Publication of BAW-10242(NP)(A), Revision 0, "Zero Power Physics Testing for B&W Reactors"

**SUBJECT: SAFETY EVALUATION FOR FRAMATOME ANP TOPICAL REPORT
BAW-10242(NP), REVISION 0, "ZERO POWER PHYSICS TESTING
FOR B&W REACTORS" (TAC NO. MB9977)**

Appendix A to BAW-10242(NP)
Response to NRC Request for Additional Information

Response to Request for Additional Information – BAW-10242(NP), "Zero Power Physics Testing for B&W Reactors" (TAC No. MB9977)

Figure 1

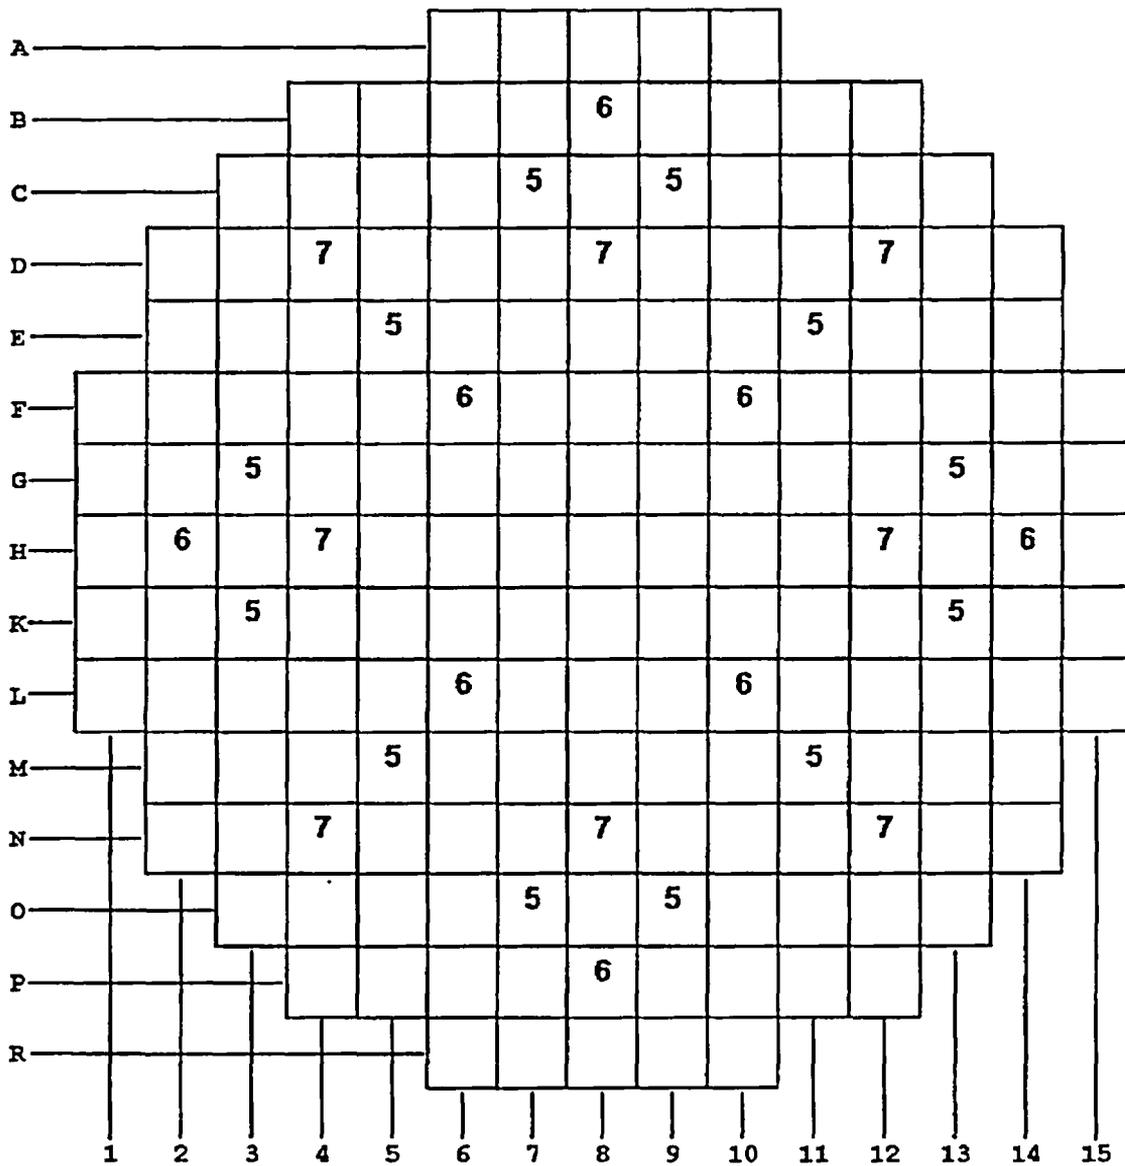
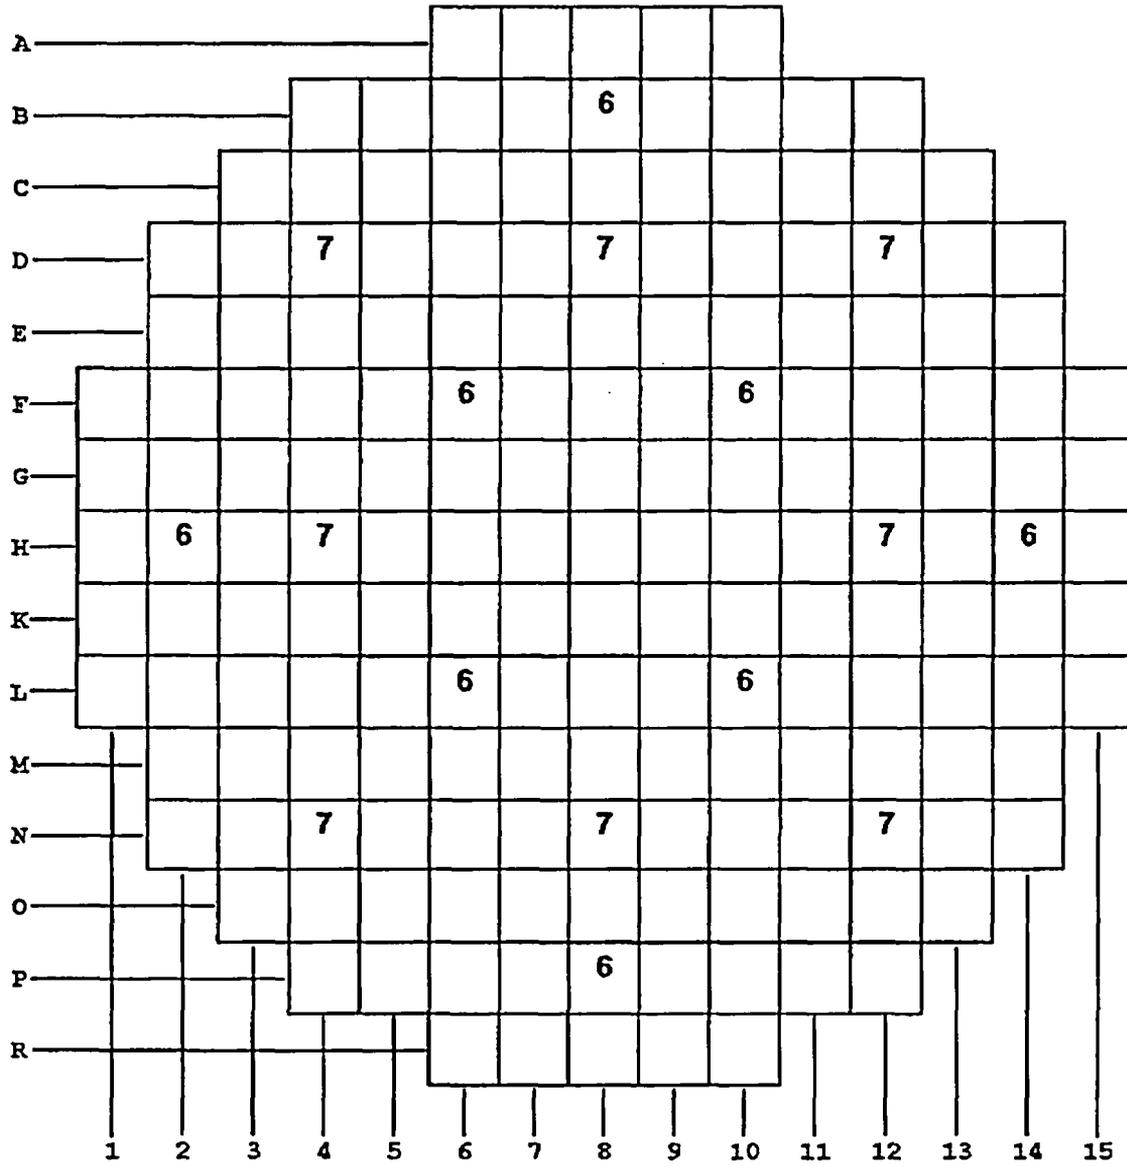
- 4) The ANS 19.6.1 Standard states that the rods measured should be “radially representative” of the core. CRG 5 locations are in close enough proximity to the CRG 6 and 7 locations such that significant additional information relative to the zero-power power distribution is not acquired by measuring CRG 5 worth, as illustrated by Figures 1 and 2.

Your submittal makes the additional argument that CRG5 is rarely used as a CRG. This essentially delegates CRG5 to the shutdown group of rod clusters. However, the distribution of the CRG5 rods into the core is clearly the same as 6 and 7, i.e., has the characteristics of the CRG.
